Subject: Communications Report Transmittal #11
Comanche Peak Steam Electric Station
Independent Assessment Program - Phase 4
Texas Utilities Generating Company
Job. No. 84056

Communications Report

Company:	Texas Utilities	<input checked="" type="checkbox"/> Telecon	<input type="checkbox"/> Conference Report
Project:	Comanche Peak Steam Electric Station Independent Assessment Program - Phase 4	Job No.	84056
		Date:	10/9/84
Subject:	Cable Tray and Conduit Support Design Status of Specific Question as of 10/9/84	Time:	2:45 p.m.
		Place:	CES-SFRO
Participants:	J. VanAmerongen	of	TUGCO (EBASCO)
	P. Huang, T. Keiss		Gibbs & Hill
	J. Russ, W. Horstman, N. Williams		Cygna

FIGURE 1

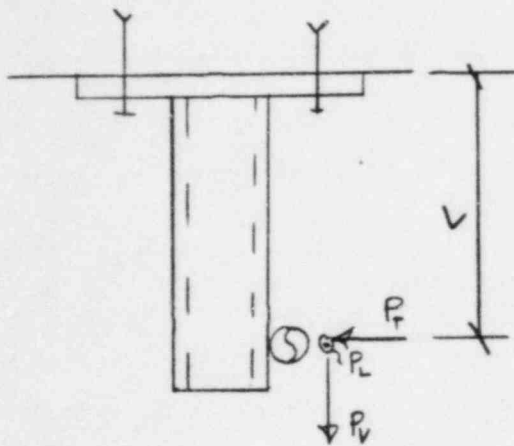
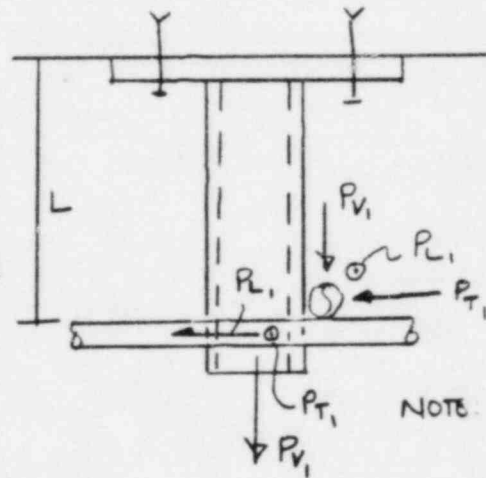
3.	<p>In the calculations for conduit supports CSM-18c, -18d, and -18f, Cygna noted that the support was designed to the conduit configuration shown in Figure 1, attached. The calculations result in a total allowable load which the support may carry. Cygna was concerned that the configuration shown in Figure 2 was the controlling case and would result in lower allowable loads.</p> <p>Mr. Kissinger agreed that Cygna was correct but the total change in loads was negligible due to the formulation shown in Attachment 1. Cygna questioned the inclusion of the vertical loads in the SRSS. A revised calculation showed that $P_1 = .53 P_o$. Mr. Kissinger stated that when considering the base conservative base plate prying factor of 1.5, the effect on the design was negligible.</p> <p>Cygna also noted that the base plate stress calculations did not include the effects due to the compressive concrete force. Mr. Bhujang checked with the site and determined that the baseplate stress calculations were conservative as they included only one-half the plate width, a distance equal to 5".</p>

5.	Cygna asked if the load case of Figure 2 from Item 3 above had been considered in the design of CSM-42a. Mr. Kissinger and Mr. Russ then reviewed calculation SCS-209C, Set 3. The calculation considered all loading configurations. Cygna also asked about the effect of concrete compressive forces in the bolt design. Mr. Kissinger stated such calculations would be included with the calculation for support IN-CSM-15a.

Therefore, this shows that the loads for the condition in Figure 2 are 1/2 the magnitude of Figure 1. Considering the vector magnitude, the design is adequate.
